Docket No. FAA-2011-1237; Airspace Docket No. 08-AWA-5

Amendment to Class B Airspace; Atlanta, GA

ACTION: Final rule.

**Modification of the
Atlanta, GA Class B Airspace Area
(Docket No. 08-AWA-5)**

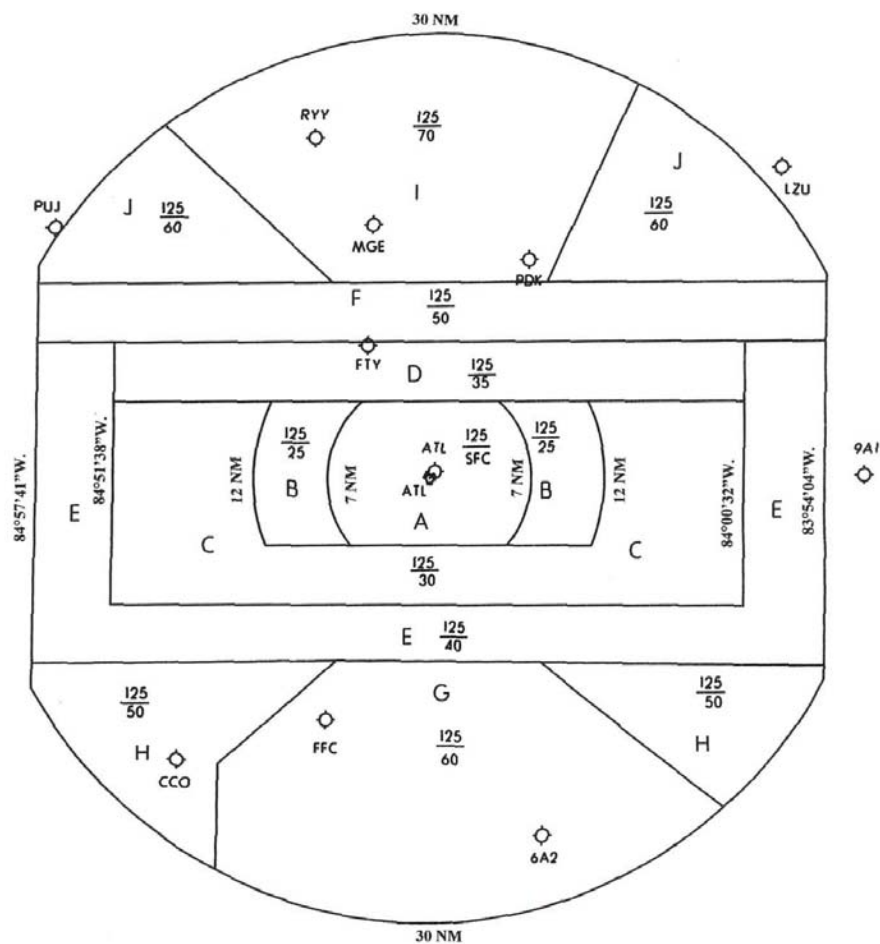
The descriptions of subareas F, I and J have been modified from that proposed in the NPRM. In light of public and Ad Hoc Committee inputs, the FAA reevaluated the Class B design in the vicinity of PDK and determined that the proposed 5,000-foot Class B floor airspace over PDK could be raised to 7,000 feet. This is accomplished by moving the northern boundary of Area F, and the southern boundary of Area I, to the south of PDK; and by moving the west boundary of the section of Area J (that lies northeast of PDK) to the east by two miles.

The FAA is amending Title 14 of the Code of Federal Regulations (14 CFR) part 71 to modify the Atlanta, GA, Class B airspace area. This action (depicted on the attached chart) reduces the overall lateral boundaries of the airspace and expands the vertical boundaries by lowering the floors of some subareas. These modifications are necessary to provide the additional Class B airspace needed to contain large turbine-powered aircraft operating to and from ATL. The modifications to the ATL Class B airspace area are summarized below. The following areas extend upward from the specified altitudes to 12,500 feet MSL:
